# Access Compliance Report

## Public Rights-of-Way

Intersection ID: 28511	Main Street: BRAY_DR	Cross Street: HOLLY_PARK_DR	Location: S
ADA ID: ABBDAA4BA170	Ramp Type: PerpDiag	Initial Pass/Fail: Fail	Overall Compliance: No
		Severity Score: 55

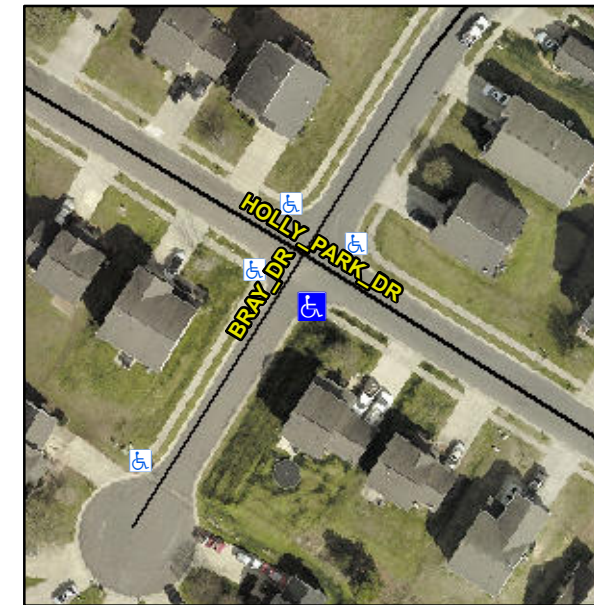
**Not Found, R304.5.1, R304.2.2, R304.5.3**

Compliance	Description	Data	Compliance	Description	Data
N/A	Ramp Length (in)	56.0	No	Ramp Slope (%)	9.9
No	Ramp Width (in)	35.0	No	Ramp XSlope (%)	9.6
N/A	Flare Type LT	N/A	N/A	Flare Type RT	N/A
N/A	Flare Slope LT (%)	N/A	N/A	Flare Slope RT (%)	N/A
N/A	Flare Traversable LT?	N/A	N/A	Flare Traversable RT?	N/A
N/A	Landing Length (in)	N/A	N/A	DWS Provided?	N/A
N/A	Landing Width (in)	N/A	N/A	DWS Contrast?	N/A
N/A	Landing Slope (%)	N/A	N/A	DWS Length (in)	N/A
N/A	Landing X Slope (%)	N/A	N/A	DWS Full Width?	N/A
N/A	Landing Curb? (Y/N)	N/A	N/A	DWS Offset (in)	N/A
N/A	Shared Landing?	N/A			
N/A	Gutter Ponding?	N/A	N/A	Gutter Slope (%)	N/A
N/A	Gutter Lip Ht (in)	N/A	N/A	Gutter X Slope (%)	N/A
N/A	Painted X Walk1?	No	N/A	Painted X Walk2?	No
	X Walk 1 Direction	To NE		X Walk 2 Direction	To NW
N/A	X Walk 1 Width (in)	N/A	N/A	X Walk 2 Width (in)	N/A
	X Walk 1 Slope (%)	6.5		X Walk 2 Slope (%)	6.1
	X Walk 1 X Slope (%)	6.9		X Walk 2 X Slope (%)	4.3

**Remove & Replace Curb Ramp With Two New Directional Ramps or Equivalent.**
